# Access Compliance Report Public Rights-of-Way (Curb Ramps)

Main Street: BANCROFT\_ST Cross Street: WALDEN\_ST Location: NW

ADA ID: RPRK211020172500 Ramp Type: Type 4 - Parallel Initial Pass/Fail: Fail Overall Compliance: No Severity Score: 2

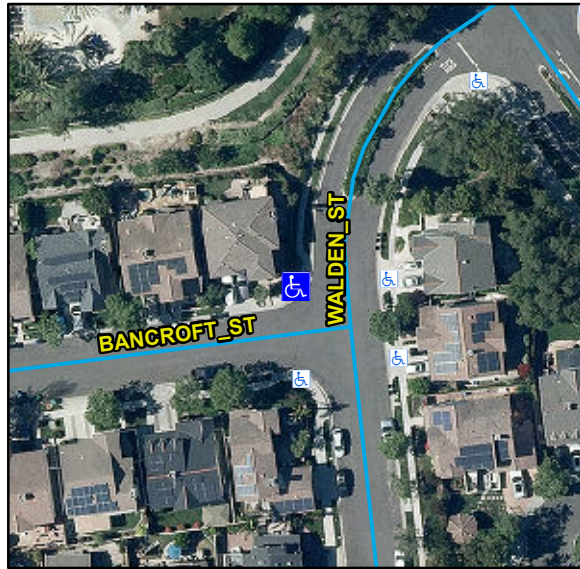
**R204.3, R304.5.3, STD 1115**

| Compliance | Description                   | Data       | Compliance | Description                   | Data |
|------------|-------------------------------|------------|------------|-------------------------------|------|
| Yes        | Ramp Cross Slope LT (%)       | 1.1        | No         | Ramp Cross Slope RT (%)       | 3.7  |

**Remove & Replace Curb Ramp With Two New Directional Ramps or Equivalent.**
